CITY OF LINCOLN NEBRASKA

FORM HD-41(73) APPLICATION FOR PERMIT TO ALTER, EXTEND OR REPAIR INDIVIDUAL SEWAGE DISPOSAL SYSTEM

FORM HD- 45(73) PLANS & SPECIFICATIONS
SEWAGE DISPOSAL SYSTEM

REAL ESTATE TRANSFER / LOAN APPROVAL

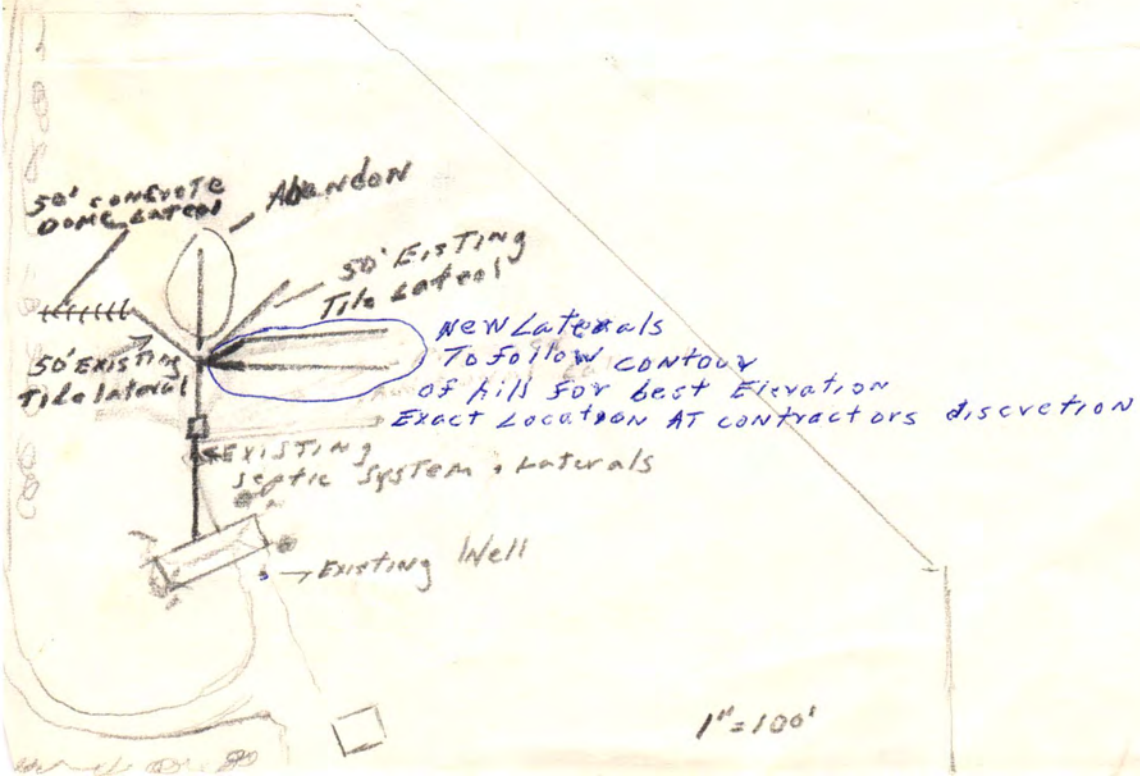
PVC
underground
duct drilled to
Adapt For septic drain
Tile
Gravel over
& under PVC
6" min gravel over
and under tile

50' concrete
Dome Lateral
Abandon
50' Existing
Tile Lateral
New Laterals
To follow contour
of hill for best Elevation
Exact Location AT contractors discretion
50' Existing
Tile lateral
Existing
Septic System & Laterals
Existing Well
1" = 100'

3. Date: Approved [X]; Disapproved [ ]
by: Jerrold C. Hood

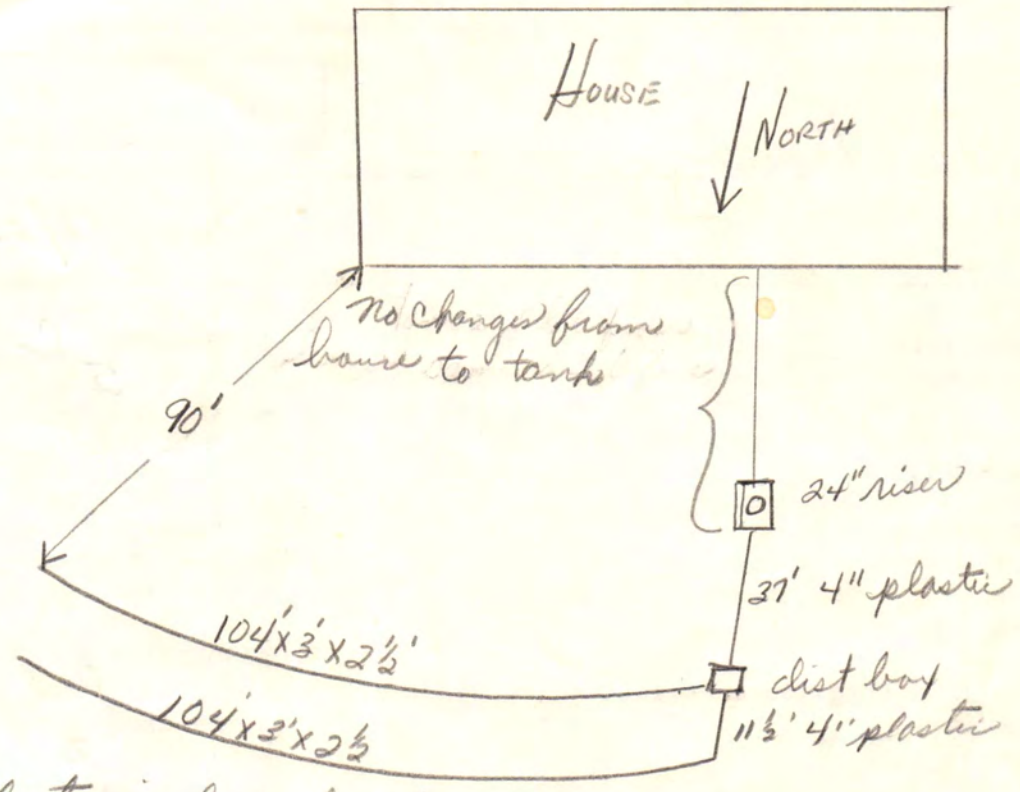
Comments: Well does not meet sanitary construction standards. Recommend checking to see if septic tank needs pumping. There was no visible malfunction of the septic system at the time of inspection. There is no record of the original installation. Thus, 5-yr provisional approval. See Attached Letter ☐

SEWAGE DISPO SYSTEM: Approved ☐ Provisional Approval: ☒

APPROVED BY Ron Mangenot DATE 3-15-89
